Technical Service Bulletin: tsb100512

Released Date: 27-Sep-2006

New LTA Water Pump

08600820

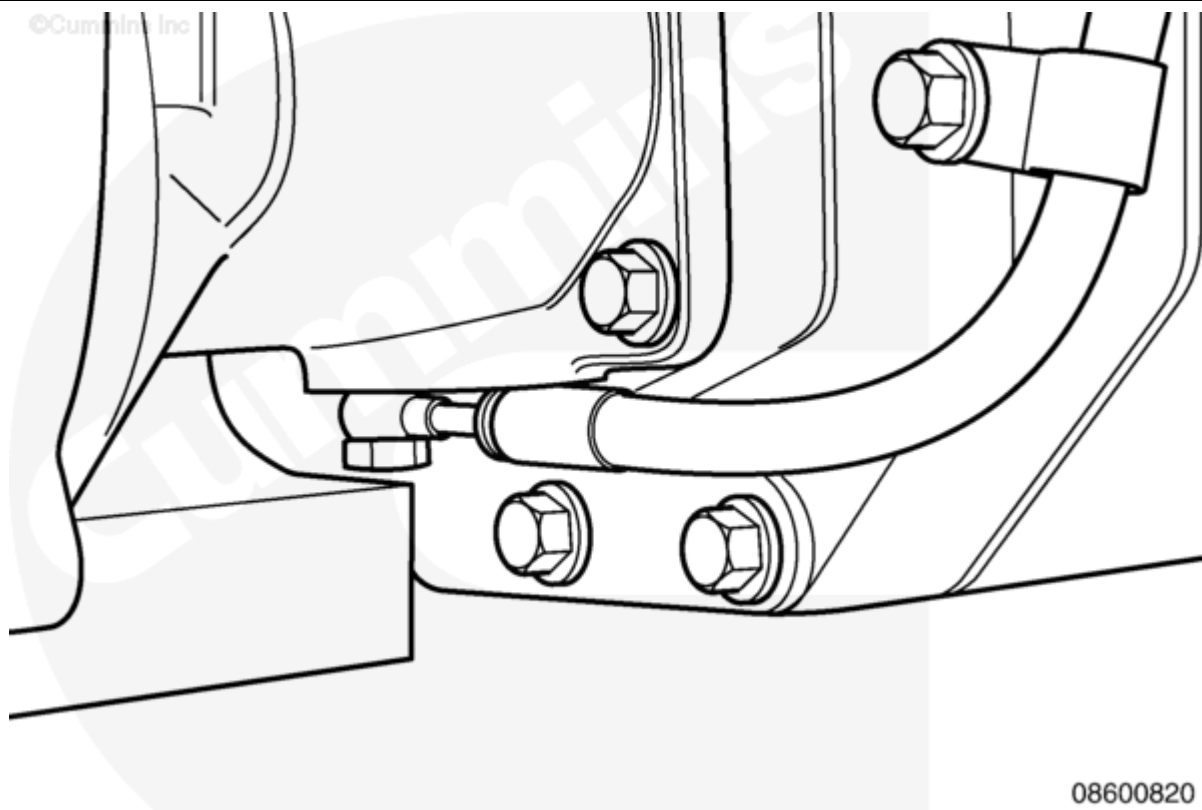
This Service Parts/Topic announces the introduction of a revised LTA water pump, Part Number 3638083, and the changes that have been included.

The improvements included a change from greased bearings to oil fed bearings, which has increased lubrication. The oil feed is taken from the side of the gear cover.

New Oil Feed, Part Number 3638095, (with new banjo type connector)

08600821

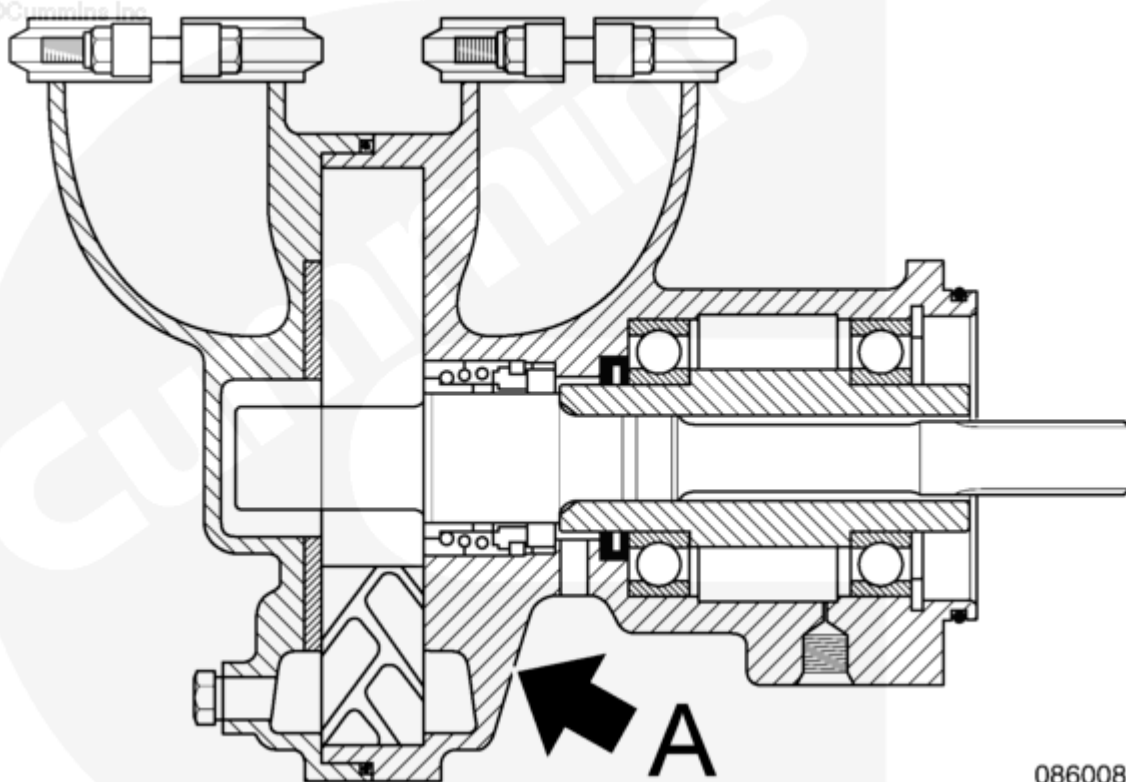
The strength of the pump body has been improved by adding a stiffening rib, as shown in the diagram below, and the introduction of a one-piece pump body.

The stiffening rib is shown, marked A.
